Comments on Changes to the Requirements Associated with Braking Compatibility of Towing Vehicles and Trailers as Proposed by Denmark in ECE/TRANS/WP29/GRRF/2012/12

The following diagrams illustrate the current requirements and those proposed by Denmark relating to the Annex 10 compatibility bands for the respective vehicles:

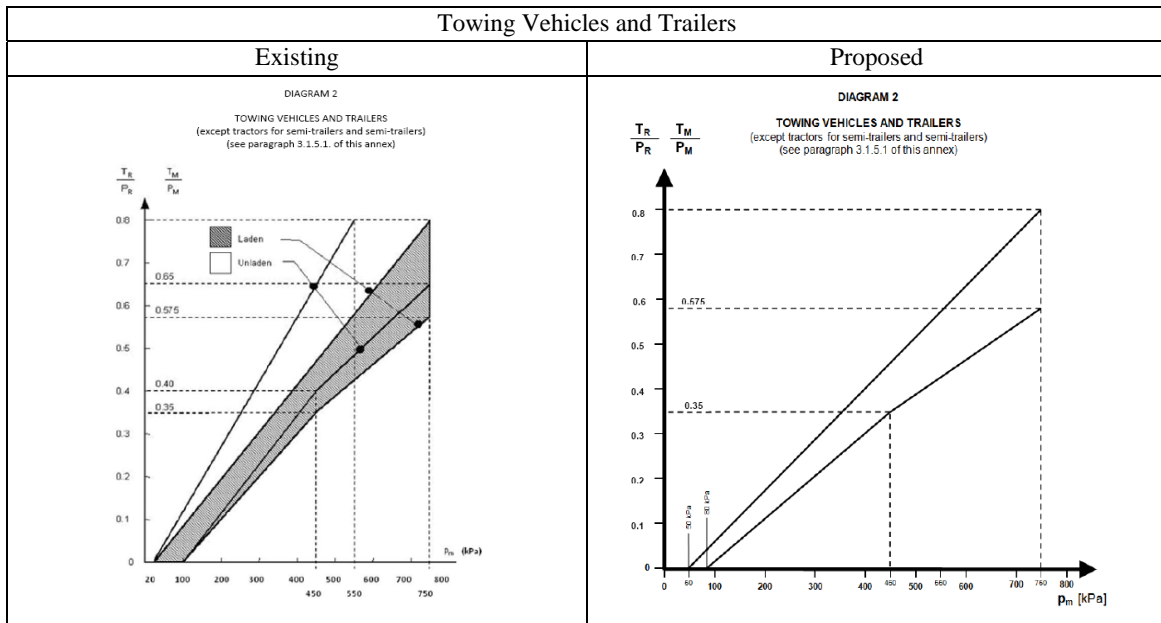
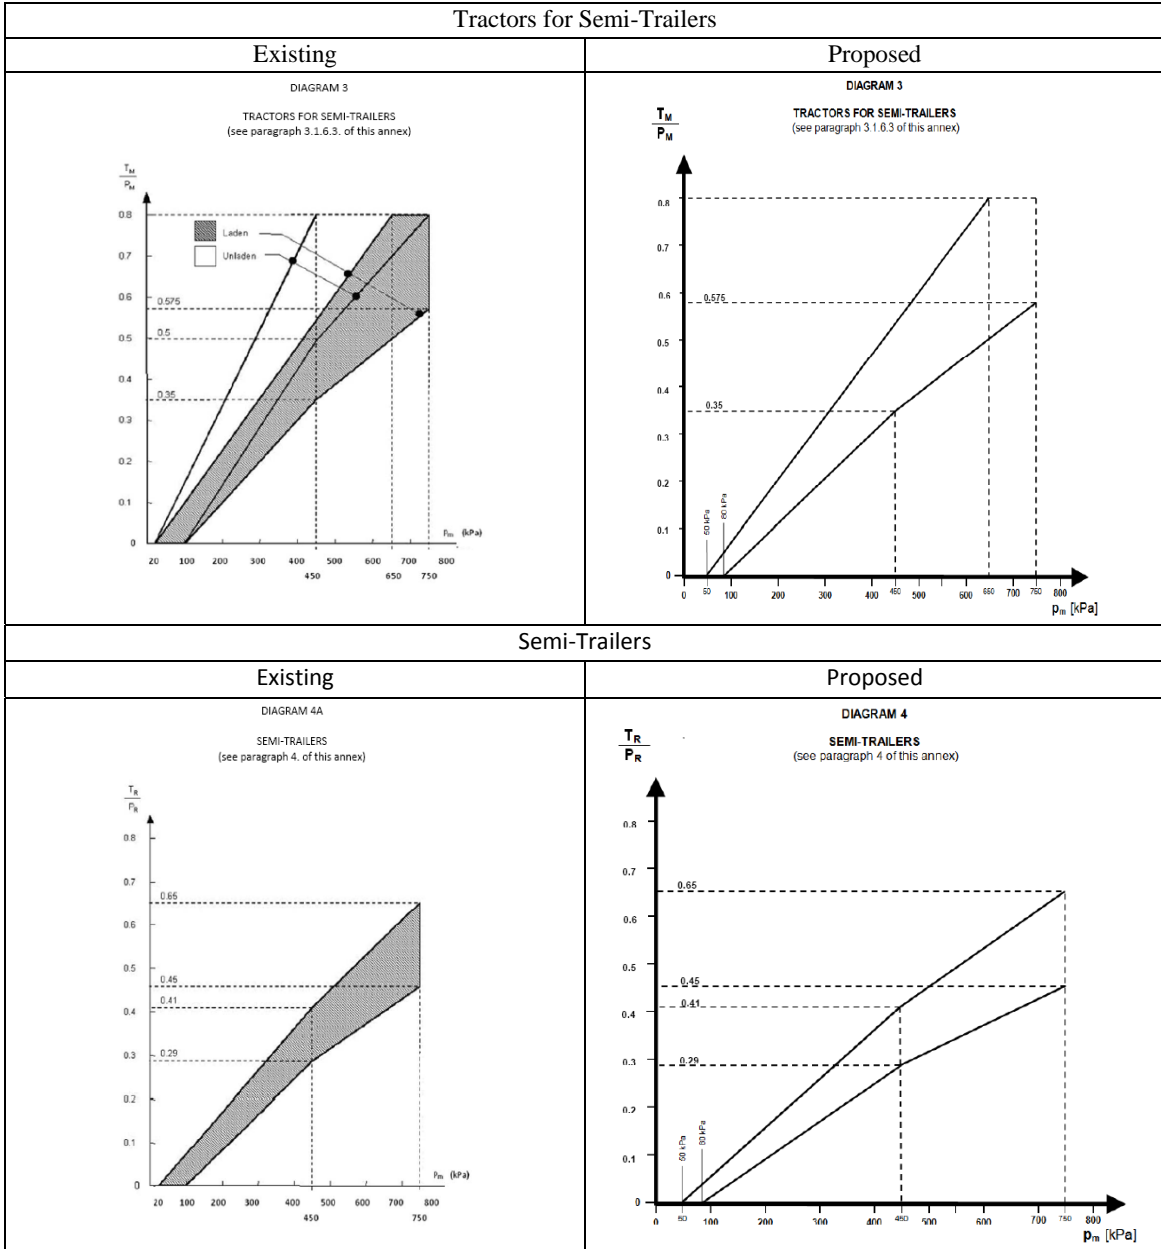
In the case of towing vehicles, trailers (including centre axle trailers) and tractors for semi-trailers it is proposed to remove the co-ordinates associated with the unladen bands and, by the amendment proposed for paragraph 1.1 of Annex 13, it would be required to fulfil the laden compatibility band up to a coupling head pressure of 200kPa for all states of load other than laden where the braking performance must be within the band up to a coupling head pressure of 750kPa. Potentially the removal of the unladen compatibility band, which is higher than the laden, will restrict the braking force that can be generated in all conditions other than laden. As it is common for vehicle manufacturers to adhere to the unladen compatibility requirements, even though they are optional, the end result will be reduced braking performance being available. If the braking specification of the current vehicles in service is taken into consideration the operation of these vehicles with a vehicle fulfilling the proposed requirements will be an increase in incompatibility as follows:

The proposal for the semi-trailer compatibility bands retains the principle of the unladen compatibility bands as there is no suggestion in the proposal to remove the reference to the unladen factor K_v which is used to construct the unladen boundaries. As a result the impact of the compatibility of tractors and semi-trailers will be:

Removal of the current unladen compatibility bands for towing vehicles, trailers and tractors for semi-trailers and replace this with having to comply with the laden compatibility bands up to a coupling head pressure of 200kPa is a major change. It is the opinion of industry that this change will increase incompatibility when mixing new vehicles with old.

In the case of semi-trailers there is no reference to removing the unladen compatibility band as the factor K_v remains to enable the co-ordinates of the unladen bands to be calculated. This will result in increased incompatibility as new tractors would be required to fulfil the laden compatibility requirement up to a coupling head pressure of 200kPa.

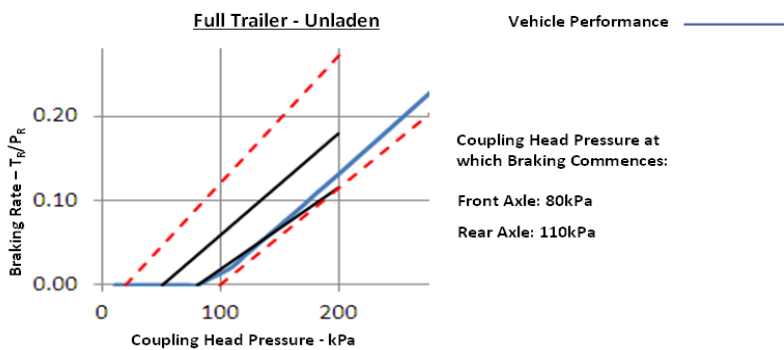
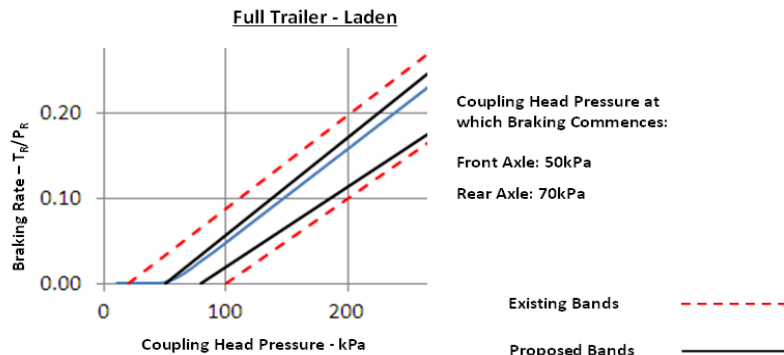
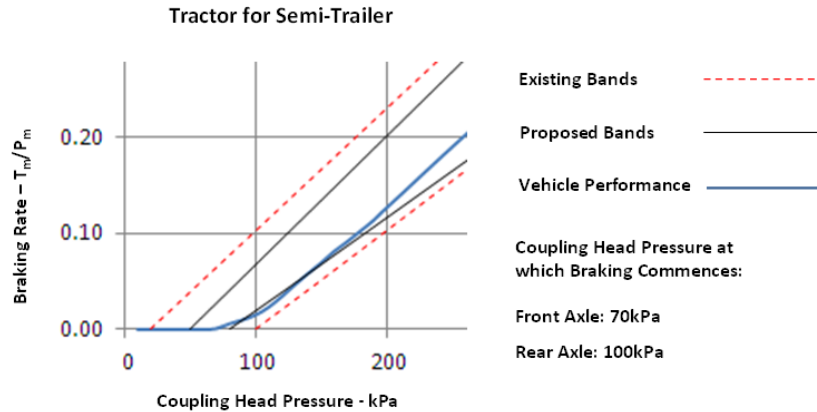
From the above it can be seen that it is often the case that following the initial generation of a braking force the vehicle performance is not linear, and is the result of the respective axles on the vehicle commencing braking at different coupling head pressures. These characteristics are typical of any conventional pneumatic braking system and could only be overcome by the use of electronic control.

The proposal from Denmark seeks to amend the above to the extent that the brakes on all axles must commence to develop a braking force within the coupling head pressure range of 50 to 80kPa. Included in the diagrams above the values of coupling head pressures when the brakes of each axle commence to develop a braking force are defined. It can be seen that it is not possible to fulfil this proposed requirement with a conventional pneumatic braking system.

Reducing the pressure range when a braking force must be generated narrows the width of the bands at lower coupling head pressures. The current pressure range of 20 to 100kPa is required to enable variations in the braking characteristics of the different axles to be accommodated. Reducing the width of the bands as proposed will effectively mandate electronic braking systems.

Requiring the brakes of all axles to commence to develop a braking force within the coupling head pressure range of 50 to 80kPa cannot be fulfilled for the same reason that the narrowing of the bands cannot be fulfilled. Imposing this requirement would again effectively mandate electronic braking systems.
